UNITED STATES PATENT AND TRADEMARK OFFICE

APPLICATION NO.	FILING DATE	FIRST NAMED INVENTOR	ATTORNEY DOCKET NO.	CONFIRMATION NO.
10/502,015	07/20/2004	Hiroo Matsunaga	Q82646	8516
23373 7590 09/07/2007 SUGHRUE MION, PLLC 2100 PENNSYLVANIA AVENUE, N.W. SUITE 800 WASHINGTON, DC 20037			EXAMINER MAKI, STEVEN D	
			ART UNIT 1733	PAPER NUMBER
			MAIL DATE 09/07/2007	DELIVERY MODE PAPER

Office Action Summary

FIG. 1

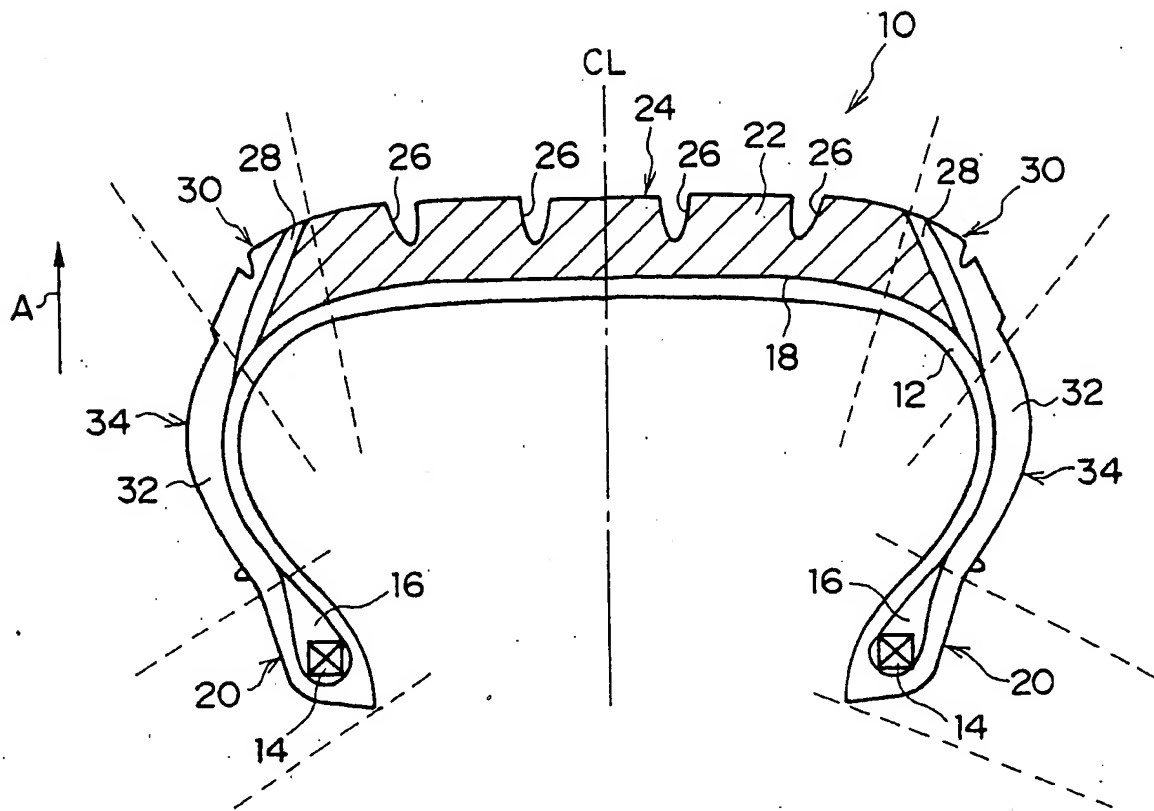
For support for amended claim 1, applicant refers to page 12 lines 13-16, page 22 lines 1-2 and original figure 1. These portions of the original disclosure fail to support amended claim 1. Original figure 1 fails to show the belt described in the original disclosure. Original figure 1 fails to differentiate side portions of the tread rubber from central portion of the tread rubber. Page 12 lines 13-16 of the specification is generic to attaching the tread rubber via a belt (not shown) on a carcass. Applicant provides no convincing reasons and/or evidence as to why page 12 lines 13-16 excludes a belt. Page 22 lines 1-2 describe figure 3D, which like figure 1 fails to show the belt.
